The Charter Township of Oakland, Michigan
Parks and Recreation Commission
INVITATION FOR BIDS

PAINT CREEK TRAIL STREAM BANK STABILIZATION

ADDENDUM NO. 1

Date of Issue: December 22, 2014

Site 1

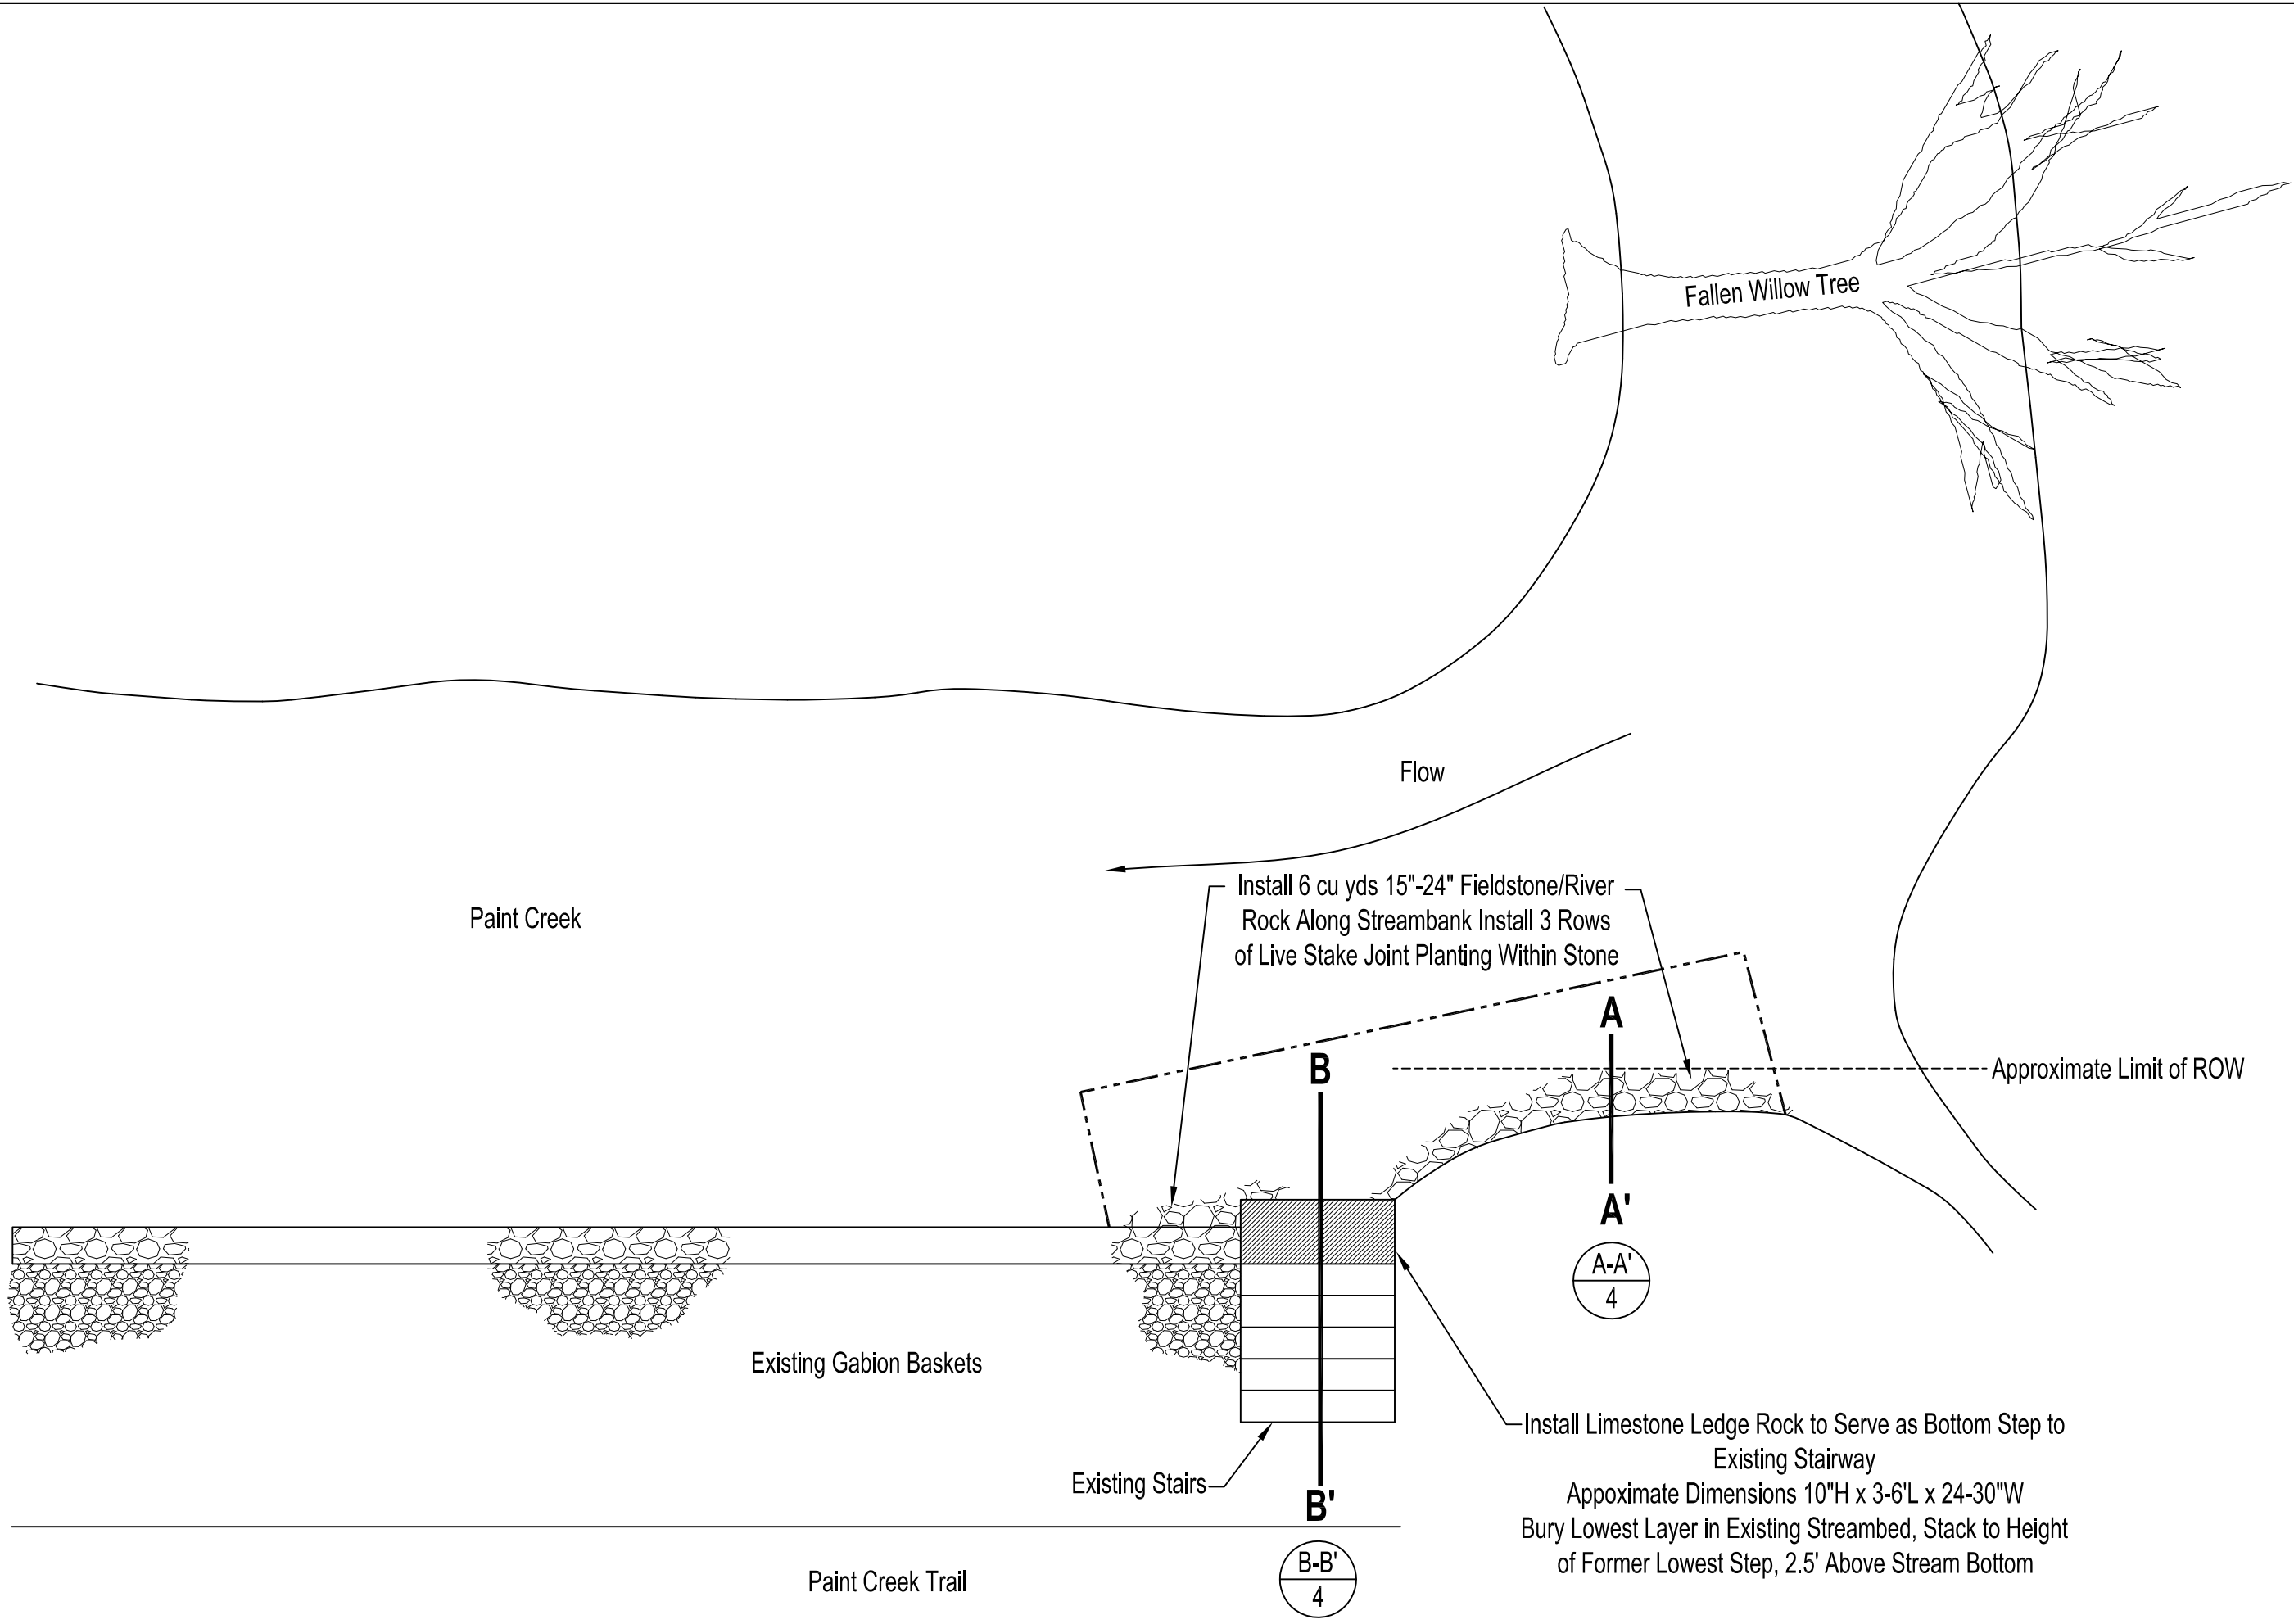
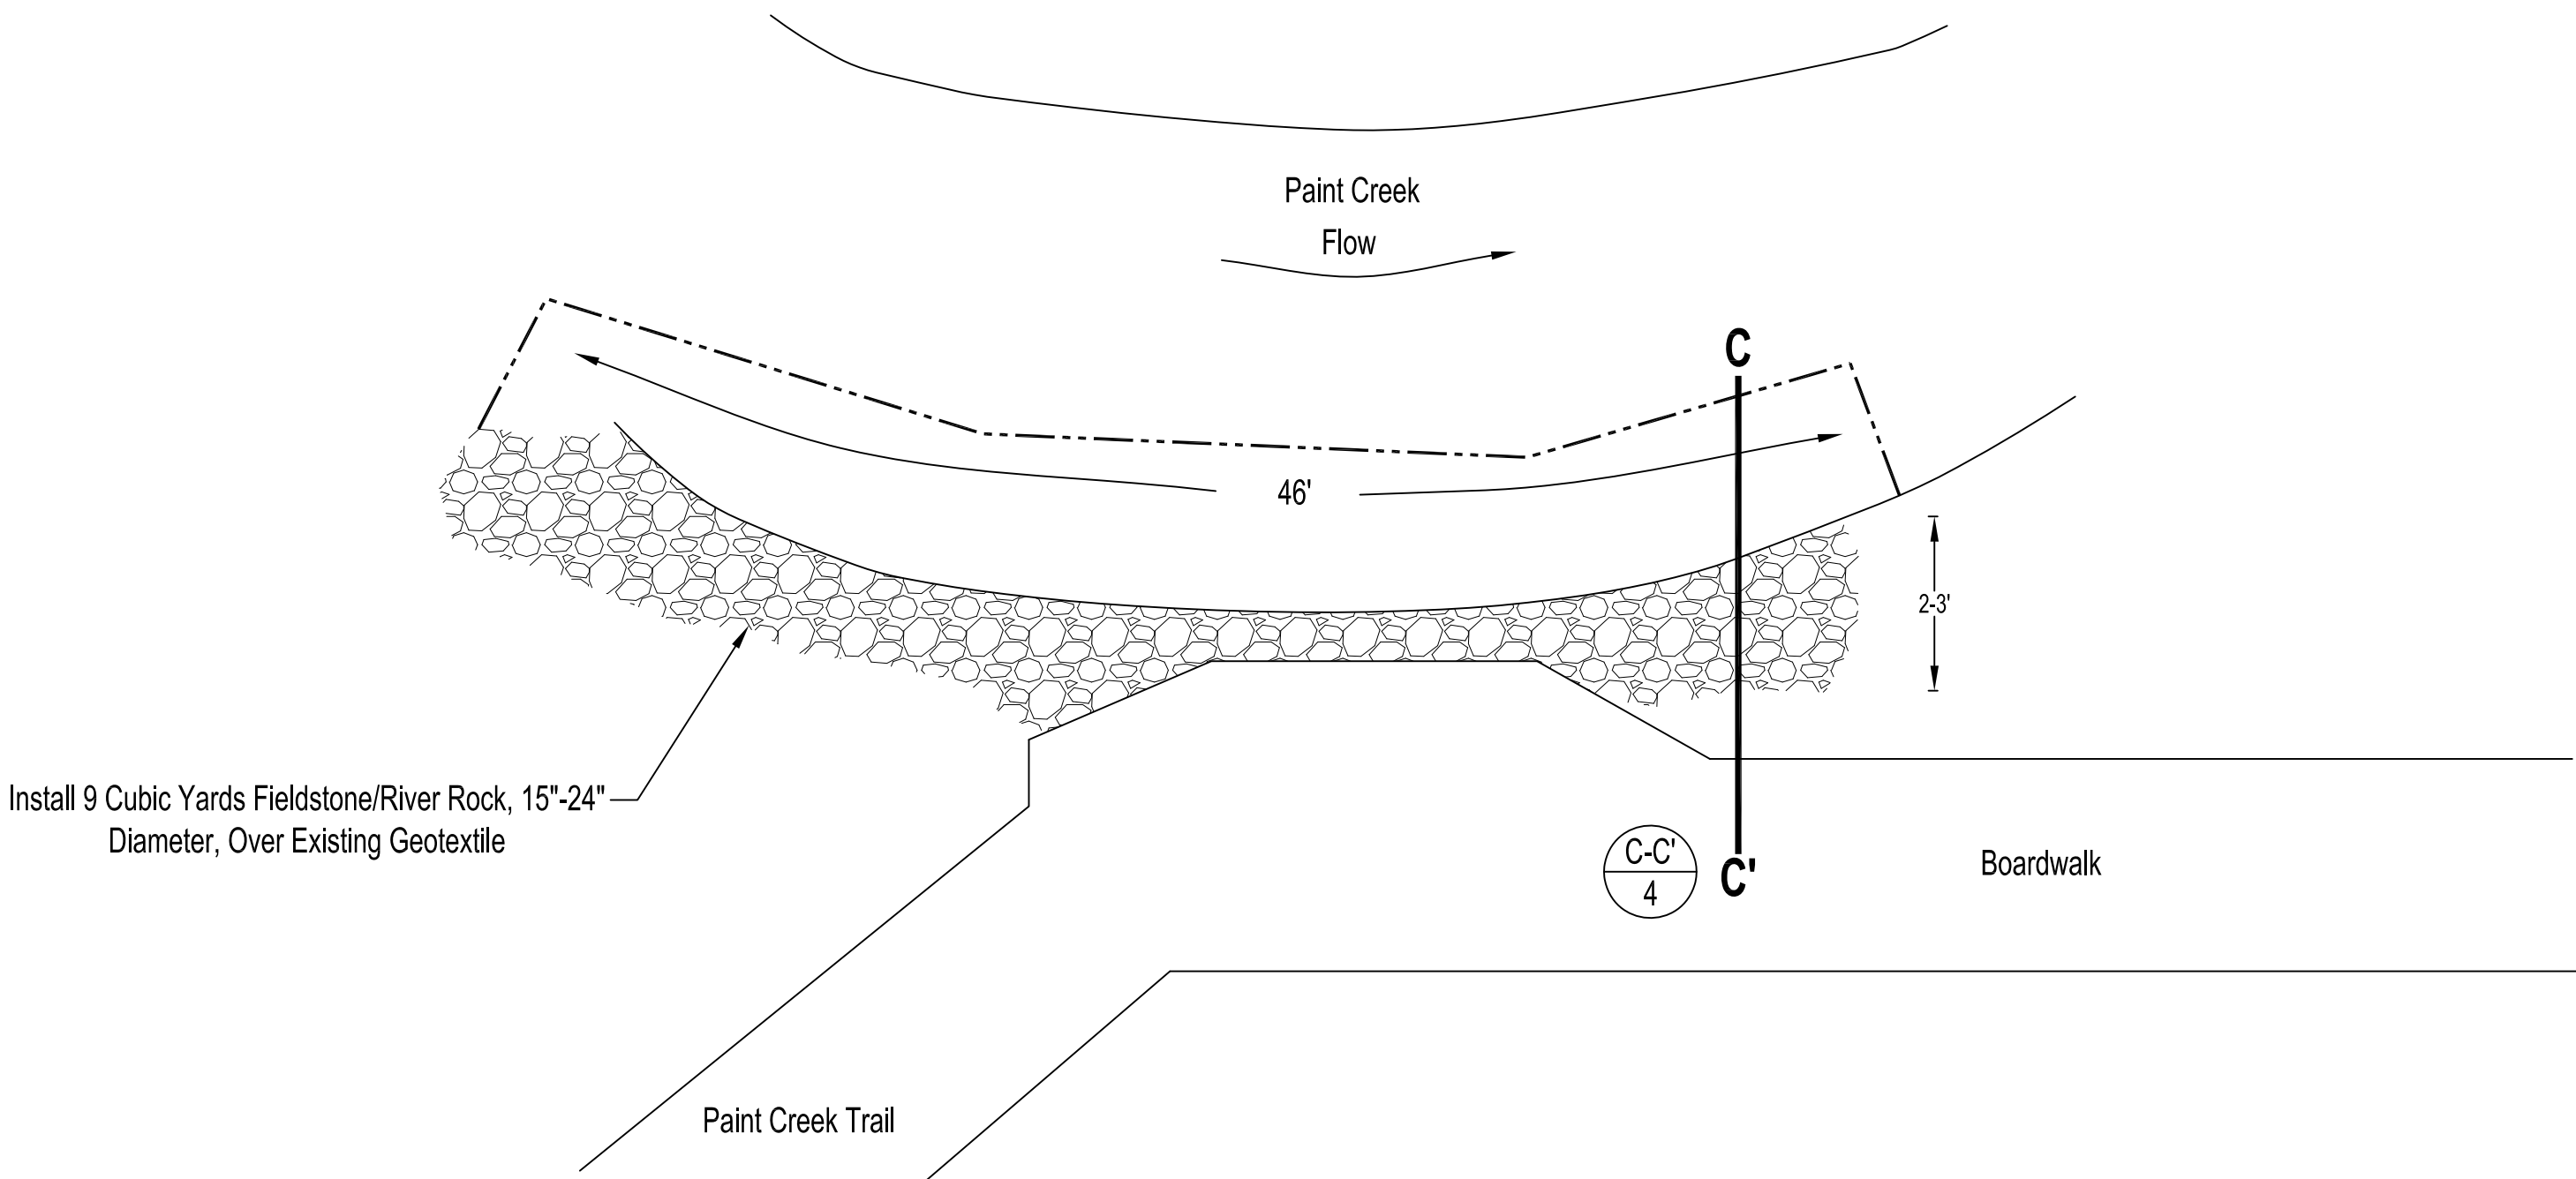
- The limit of the 50-foot Trail ROW at Site 1,
- A seed mix for site restoration at Sites 1 and 2 if brush is cleared for site access,
- A correction for the size of field stone to be installed at Site 2,
- Requirements for securing logs together in the Site 3 log cribwall, and
- The seed mix for use at Site 3.

- Each course shall be secured to the preceding course with spikes or rebar.
- Backfill in and around timber crib with stone from bottom of excavation to an elevation equal to or greater than the OHWM. Course above the OHWM, to an elevation of 818.46 (datum), shall be filled with compacted fill soil.

Paint Creek Shoreline Restoration
Grading Plan - Sites 1 & 2

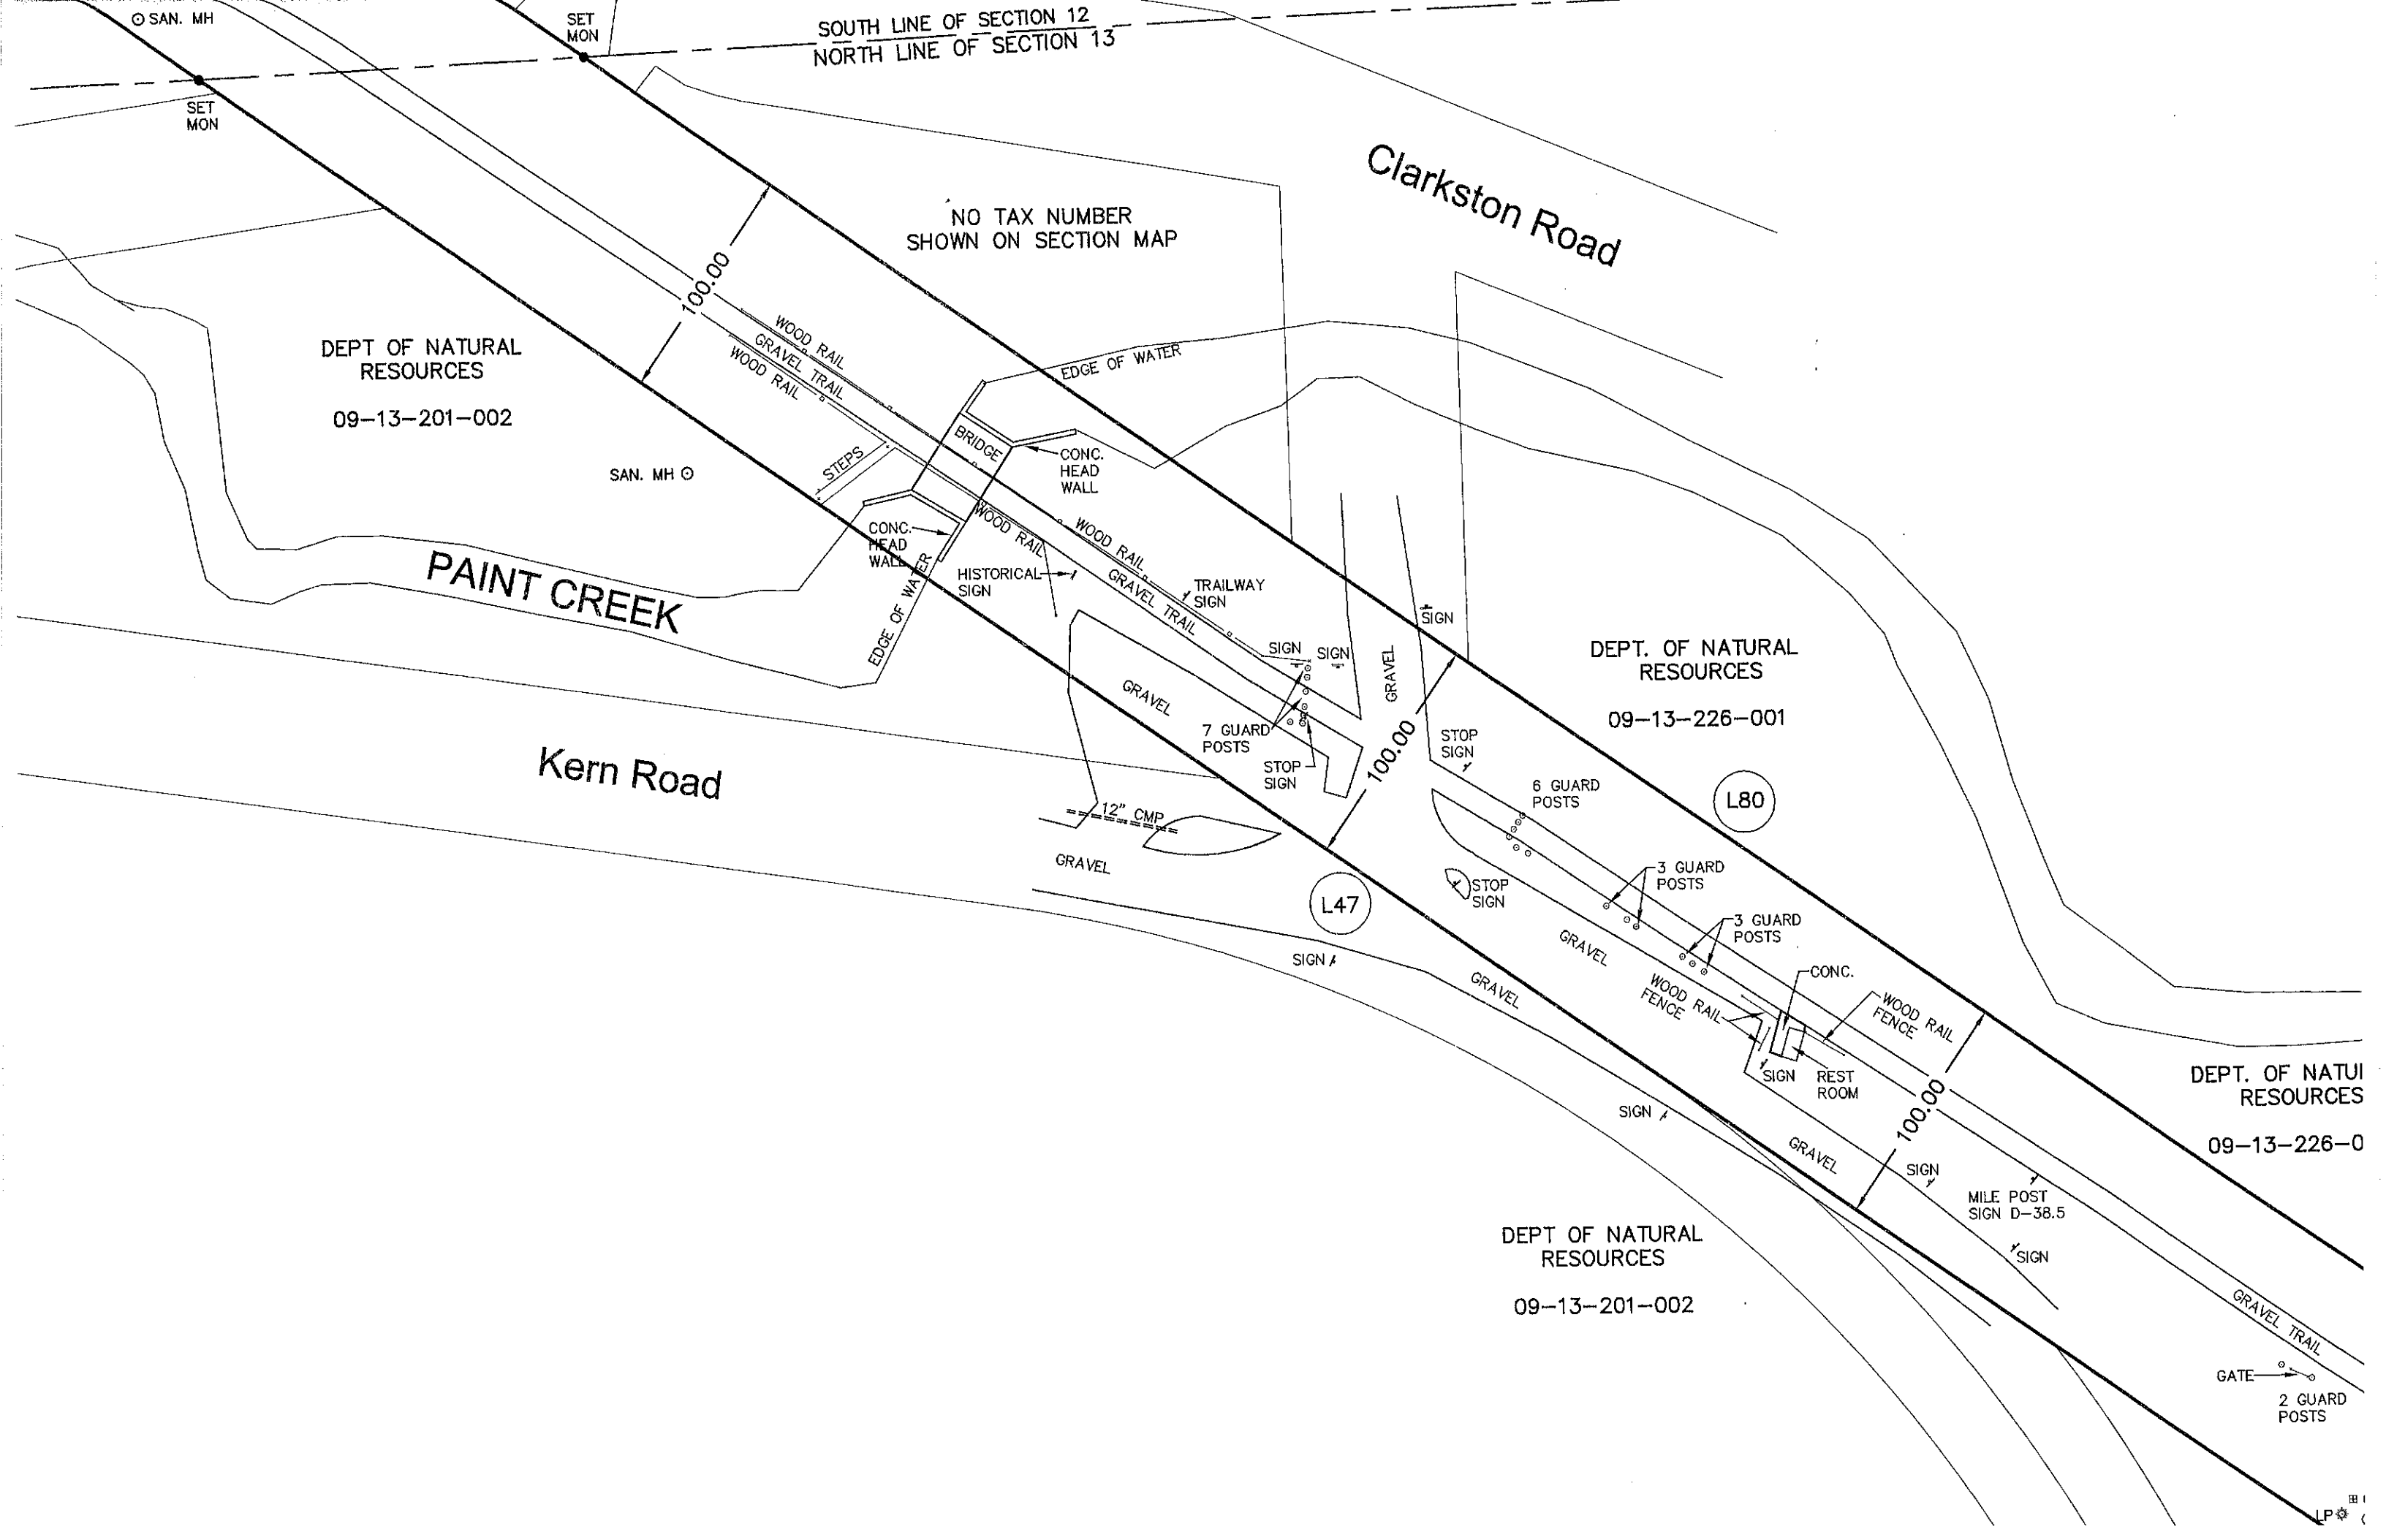
If tree/brush removal necessary for access to sites 1 and 2, site shall be rescored and reseeded with Woodland Seed Mix:

Woodland Seed Mix		
Seeding Rate 6.5 lbs/acre		
4 lbs grasses * 2.5 lbs forbs		
28.75 lbs temporary cover grasses		
Scientific Name	Common Name	Oz/Ac
Grasses & Sedges		
<i>Bromus purgens</i>	Hairy wood chess	2.00
<i>Carex cristatella</i>	Crested sedge	0.50
<i>Carex spengelii</i>	Long-beaked sedge	0.30
<i>Elymus villosus</i>	Silky wild rye	12.00
<i>Elymus virginicus</i>	Virginia wild rye	40.00
<i>Glyceri striata</i>	Fowl manna grass	1.00
<i>Histrix patula</i>	Bottlebrush grass	7.40
<i>Junus tenuis</i>	Path rush	0.80
